**Re: Stormwater Investigation Work Plan  
Coakley Landfill – North Hampton and Greenland, New Hampshire**

On behalf of the Coakley Landfill Group (CLG), CES, Inc. (CES) is hereby submitting a revised Stormwater Investigation Work Plan (Work Plan) that has incorporated United States Environmental Protection Agency (USEPA) comments contained in a September 26, 2018 letter to Peter Britz of the Coakley Landfill Group (CLG).

**STORMWATER INVESTIGATION  
WORK PLAN  
COAKLEY LANDFILL SUPERFUND SITE  
NORTH HAMPTON  
AND GREENLAND, NEW HAMPSHIRE**

**FIGURE 1**

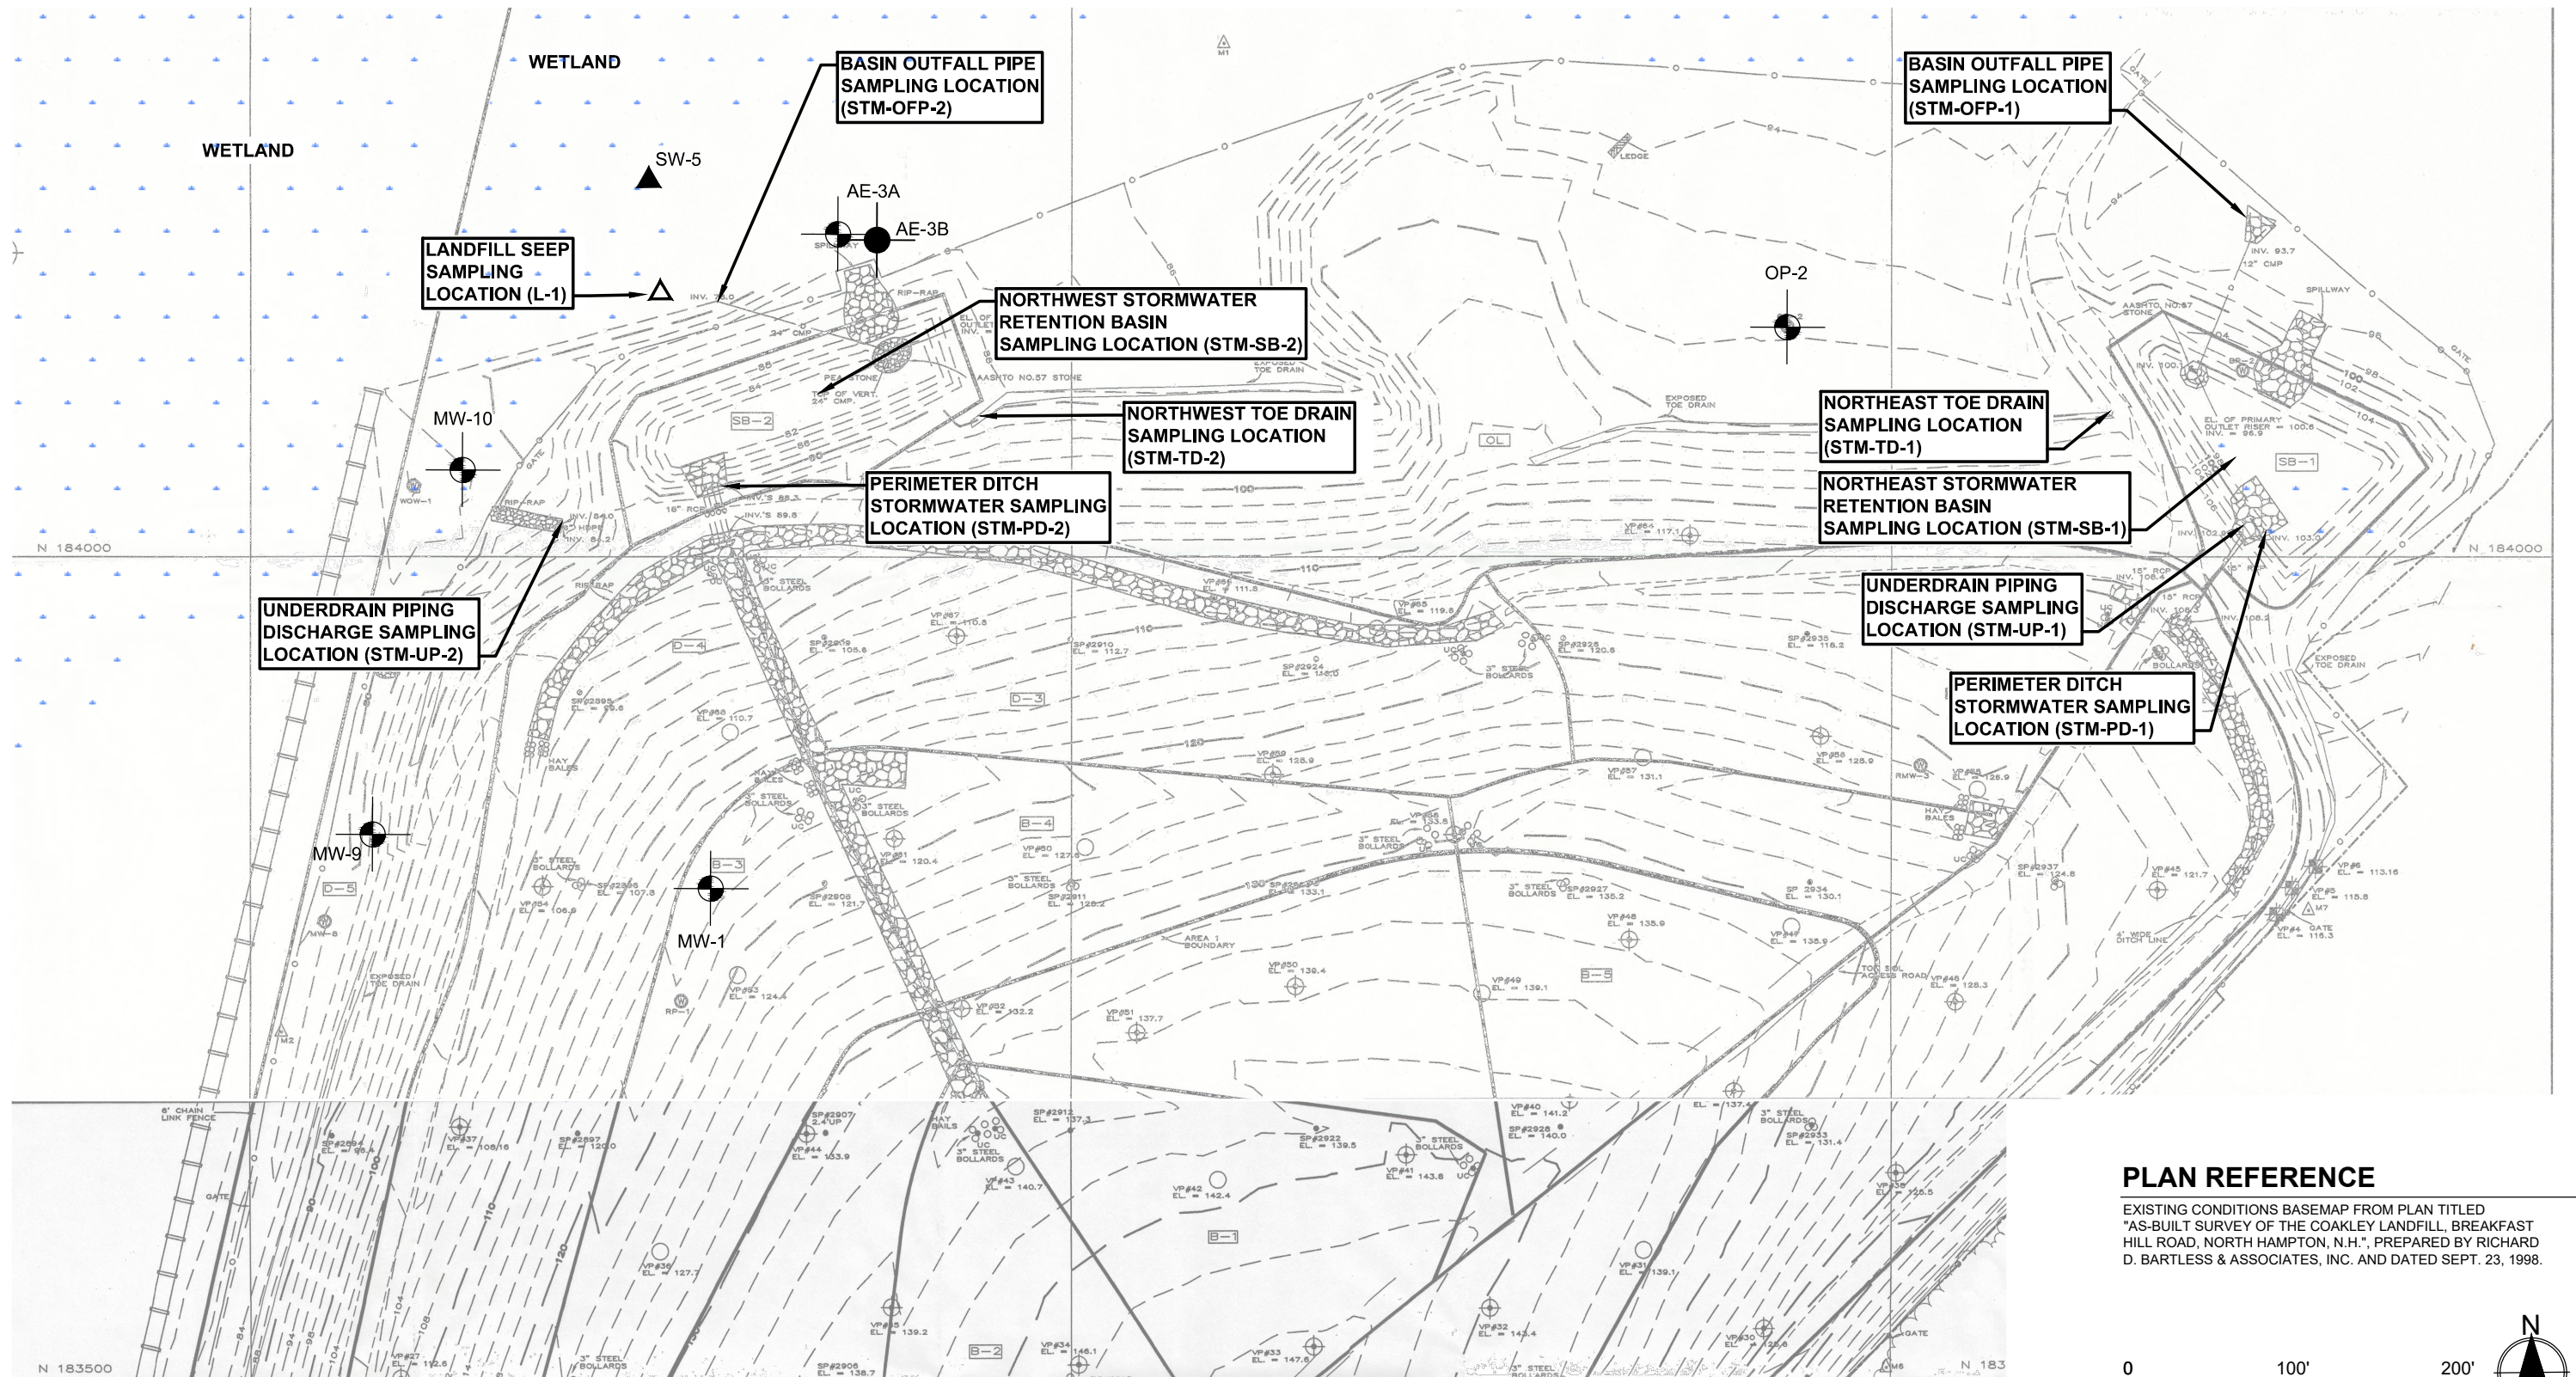
- 6. In addition to the sampling location specified in Section 3.2.1, the CLG shall also collect samples from each of the two retention basins when samples are collected from the other locations proposed in Section 3.2.1. The samples shall be analyzed for at least PFAS and 1,4 dioxane.**

*The CLG will include the collection of water samples from each of the two retention basins when samples are collected from the other stormwater investigation sampling locations as outlined in Section 3.2.1 and analyzed for PFAS and 1,4-dioxane.*
